## PLAN COMMISSION

**BLOOMINGTON PLAN COMMISSION****STAFF REPORT – Second Hearing****Location:** 723 W. 1<sup>st</sup> Street, 709 W. 1<sup>st</sup> Street, 607 W. 1<sup>st</sup> Street**CASE #:** ZO2025-12-0018**DATE:** February 12, 2026**PETITIONER:** Bloomington Redevelopment Commission  
401 N. Morton Street, Suite 130, Bloomington, IN**CONSULTANT:** Alli Thurmond (Range Co/Flintlock)  
512 N. Mission Blvd, Fayetteville, AR**REQUEST:** The petitioner is requesting to rezone approximately 6.3 acres to Planned Unit Development and a request for approval of a District Ordinance and Preliminary Plan.**BACKGROUND:****Area:** 6.3 acres

### Hopewell South Planned Unit Development (PUD)

## WYLIE STREET

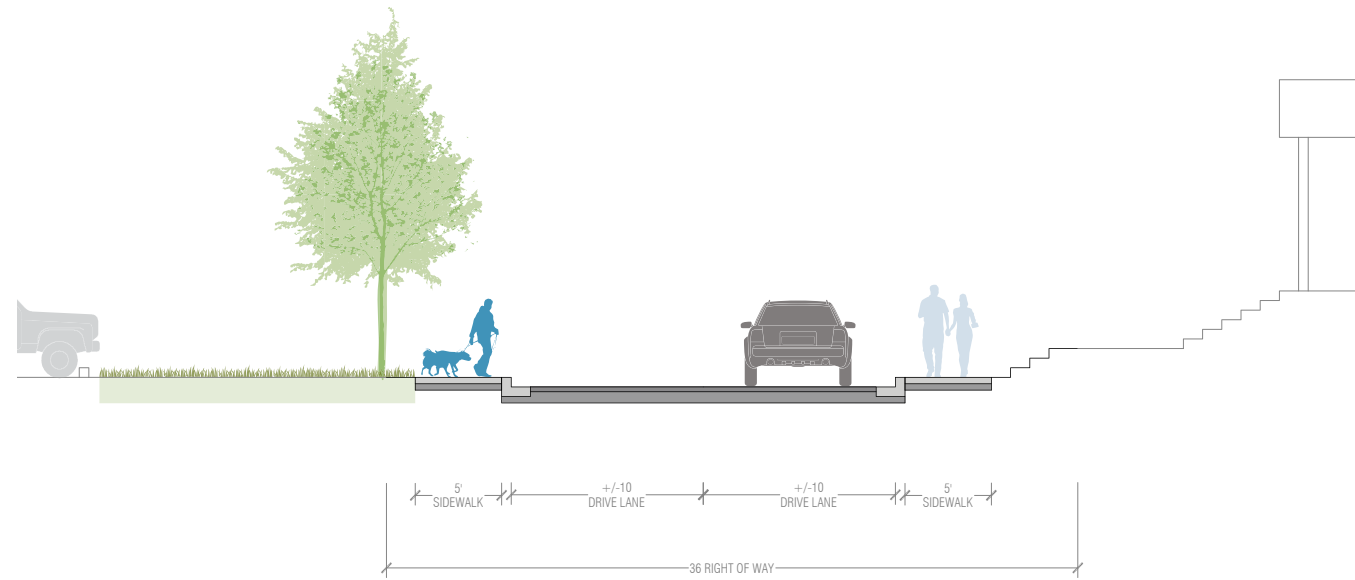
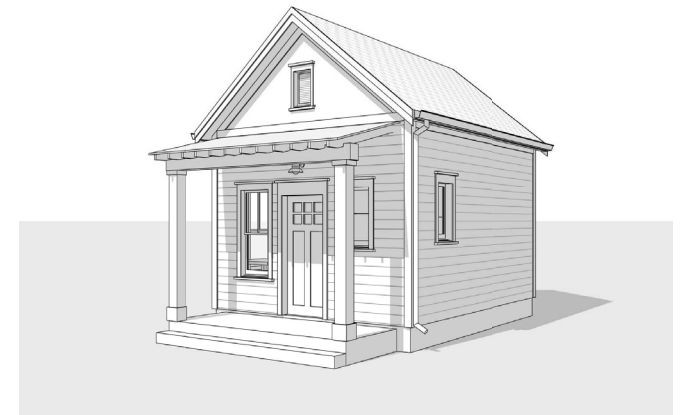
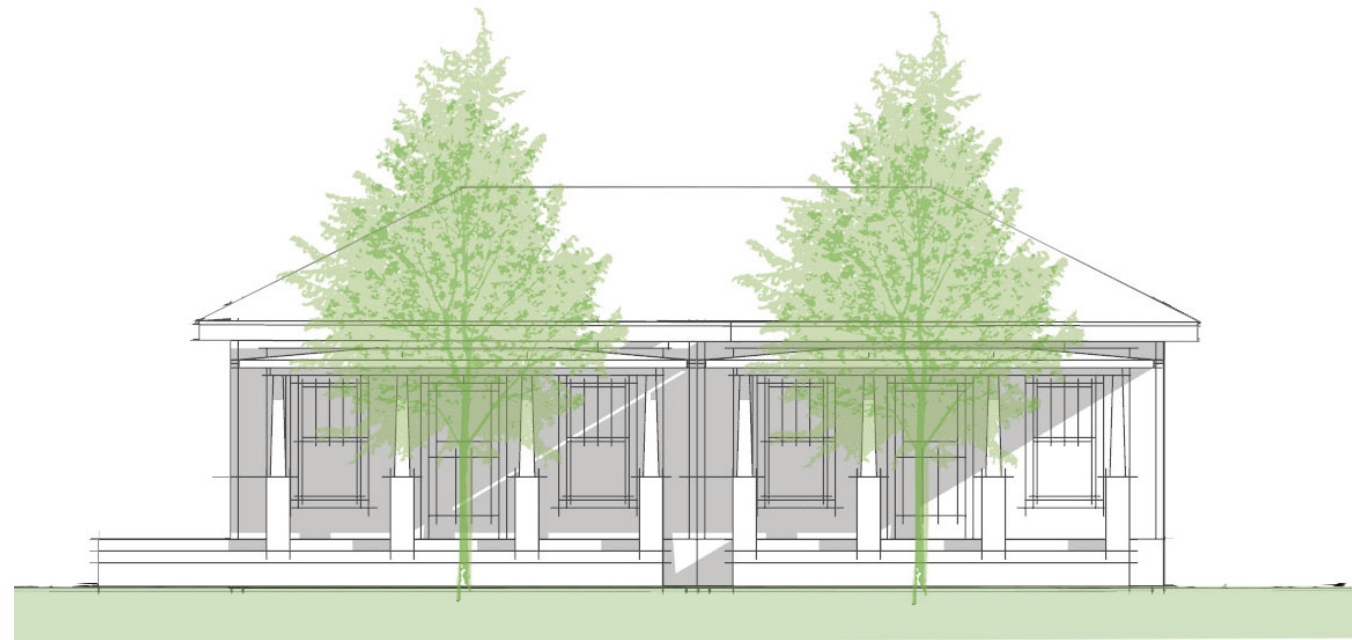
- The Transportation Plan would require a total 84' of right-of-way (42' from centerline). There is currently approximately 20-25' of right-of-way from centerline. The proposed cross section within the PUD for Rogers Street shows a dedication of 31' from centerline for right-of-way.

- Jackson Street
  - The Transportation Plan would require a total of 60' of right-of-way. With this petition Jackson Street would be constructed through this site to connect to 1<sup>st</sup> Street to the north and Wylie Street to the south. The City's recent improvements to 1<sup>st</sup> Street constructed an intersection along 1<sup>st</sup> Street for Jackson Street to connect to and it is in place. In order to maximize housing potential, while also balancing appropriate infrastructure needs, the petitioner is proposing a 48' right-of-way that would include 5' sidewalks and 5' tree plots on both sides, 2- 10' travel lanes, and a 7' wide on-street parking lane on the east side.

- Wylie Street
  - The Transportation Plan would require a total of 60' of right-of-way. But, of residential streets, the Plan also states "in order to preserve existing neighborhood fabric, existing streets shall not be required to conform to these cross-section standards". There is currently approximately 40' of right-of-way. The proposed cross section shows maintaining the existing right-of-way line with no additional dedication. There is currently an approximately 4.5' monolithic sidewalk along the north side of Wylie Street along this frontage that would be replaced with this petition with a monolithic 5' sidewalk. There is also on-street parking along the north side of Wylie Street along this property frontage which is proposed to remain. The proposed cross section shows maintaining the current monolithic sidewalk.

- Fairview Street
  - The Transportation Plan would require a total of 60' of right-of-way. Fairview Street currently extends through the site and would be removed and reconstructed with this proposal. In order to maximize housing potential, while also balancing appropriate infrastructure needs, the petitioner is proposing a 48' right-of-way that would include 5' sidewalks and 5' tree plots on both sides, 2- 10' travel lanes, and a 7' on-street parking lane on the east side.
